**From:** Barrie Tankel [REDACTED]  
**Sent:** 11 October 2016 16:44  
**To:** Quigley, Elaine; Planning  
**Subject:** 45 Lancaster Grove 2015/2534/P

## 45 Lancaster Grove London NW3 4HB

### Objection to Planning Application (Revised at 29 Sep 16)

Application Ref 2015/2534/P

Appendix  
 B  
 2015/2534/P

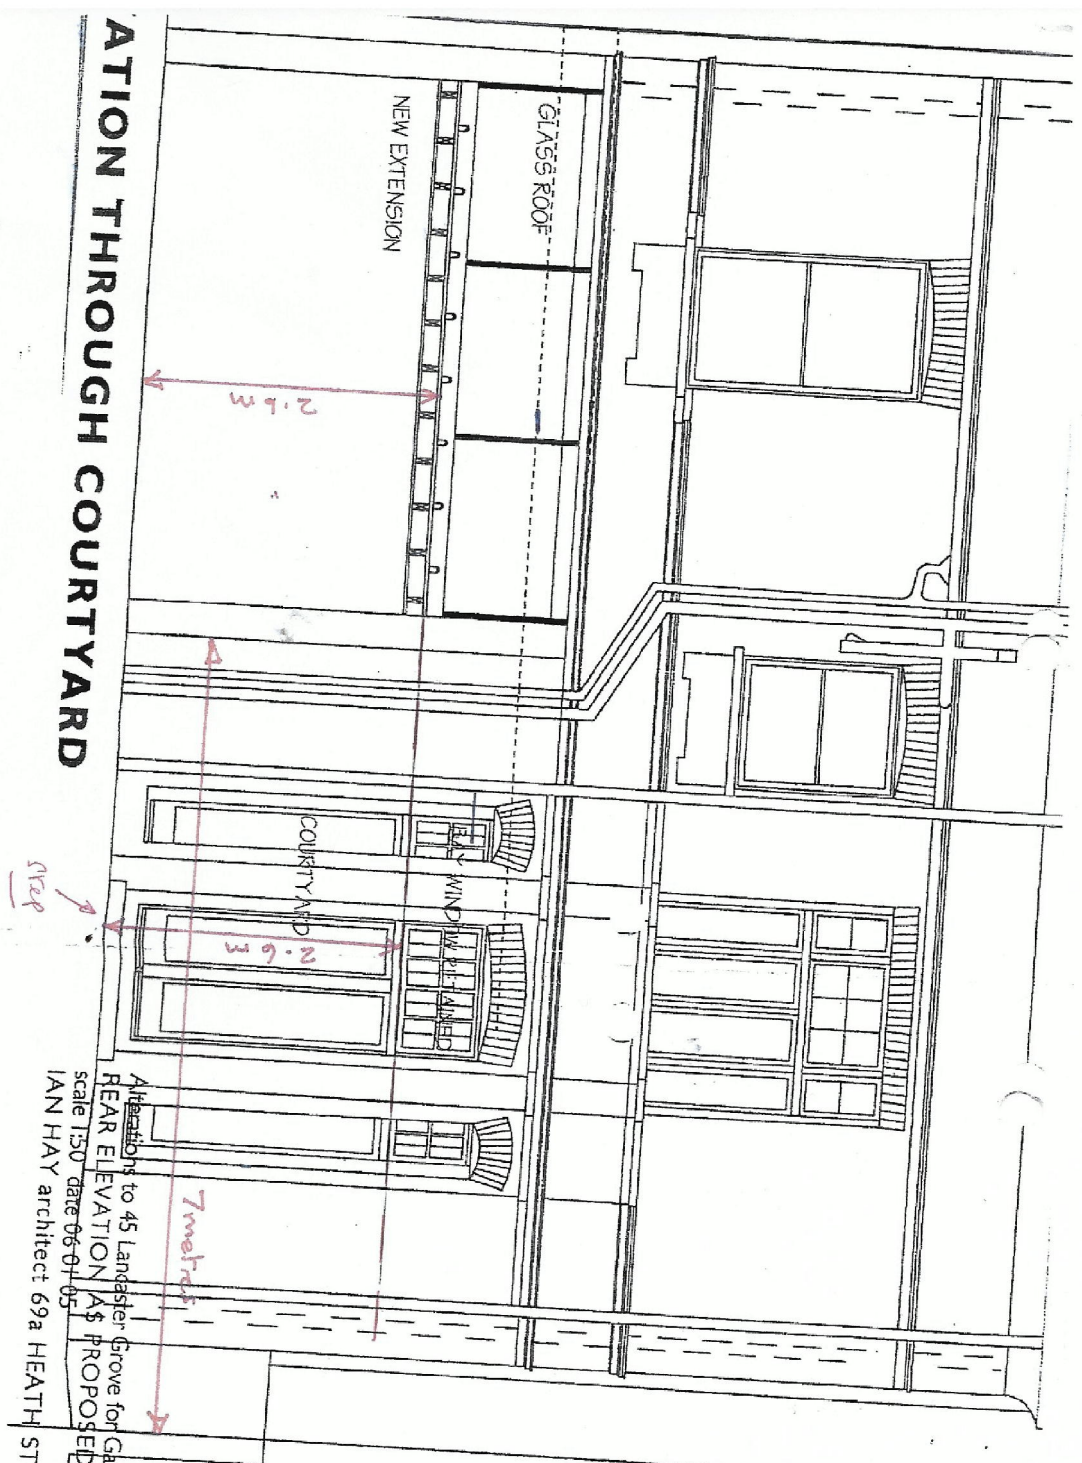
- v. The correct base point is 0.220 m below the point used by the applicant as measured on the right hand side of the extension, so in reality the proposed extension is 2.82 m high. This represents an increase of 460 mm on the demolished extension.

CORRECT HEIGHT OF  
 ROOF LINE WHEN  
 TOP OF ROOF IS  
 2.6m above ground  
 level

Alterations to 45 Langster Grove for Gabrielle  
 REAR ELEVATION AS PROPOSED  
 scale 1:50 date 06-01-05  
 IAN HAY architect 69a HEATH STREET

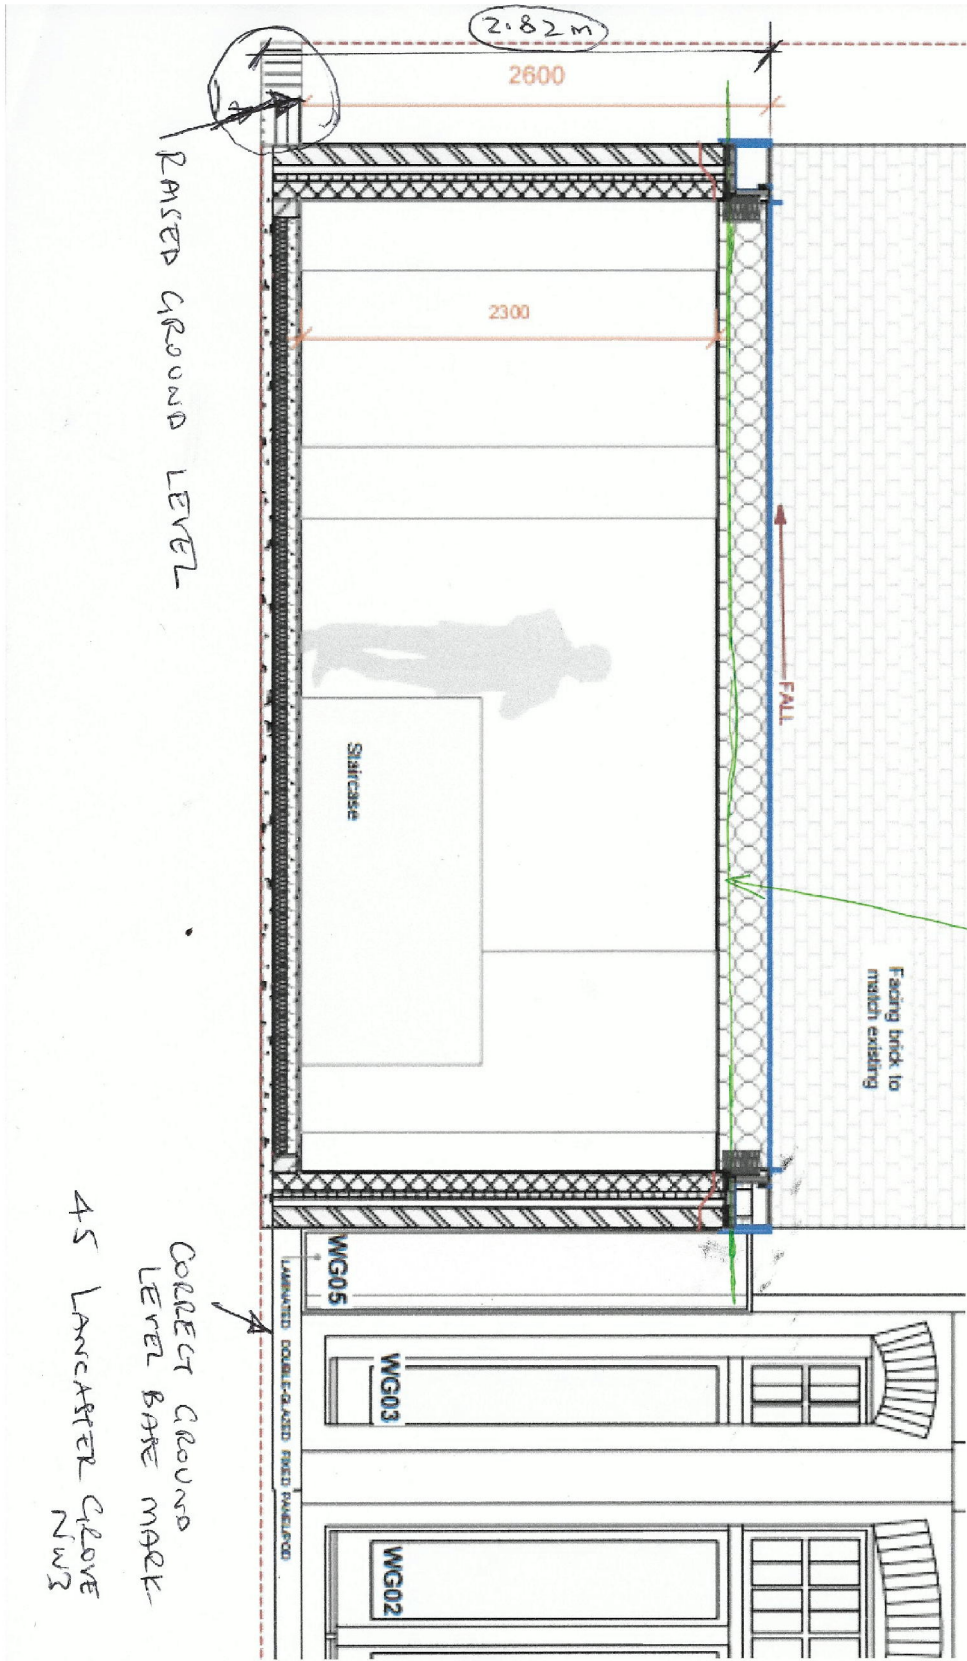
- ii. The original demolished extension was 2.4 m high.
- iii. The 2008 approved scheme was 2.6 m high. The height can be measured on the section 933/15 and it is also referred to in the Officers Delegated report. (Appendix A)

- iv. Whilst the proposed height is now shown as 2.6 m from ground level to top of roof, it is measured from a raised level on the left hand side of the extension, which raises the roof line above the previously approved extension. The applicants dimension is therefore misleading if meant to relate to the original height.
